PRODUCT UPDATE

#230

DCH Spanner Replaced with DCM Sockets for Conical Nuts

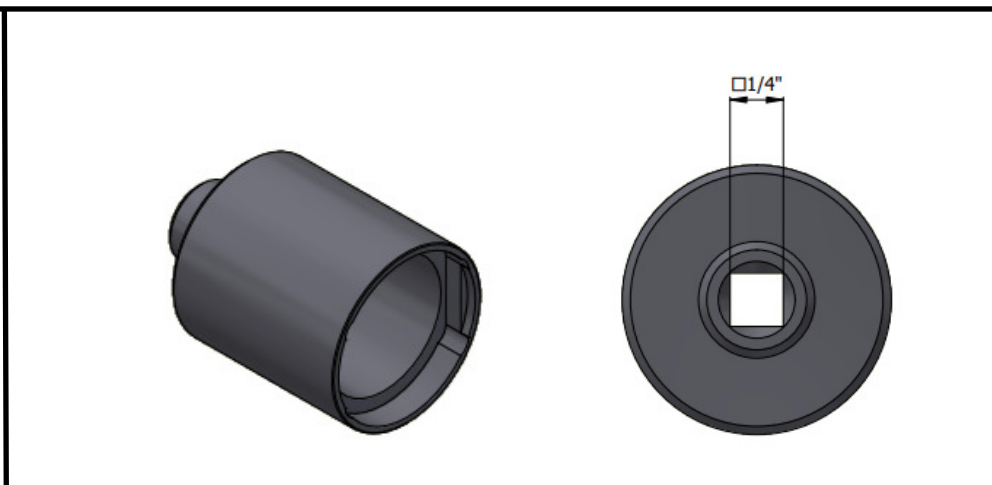
The DCH spanner tools for tightening the conical nuts of the panel mounted receptacles are becoming obsolete and replaced with the DCM sockets. The DCH spanner tool is hand-tightened so it can be difficult to determine if the conical nut is torqued to the correct value. The DCM Sockets are designed to fit a 1/4" square drive which can easily be adapted to a torque tool preset to the appropriate torque value.

The DCM sockets are made from Stainless Steel and have PEEK inserts to avoid scratching the surface.

Once inventory is depleted the DCH spanner tool will become obsolete and replaced with the DCM Sockets. Please see the chart on the next page with the new design part numbers.
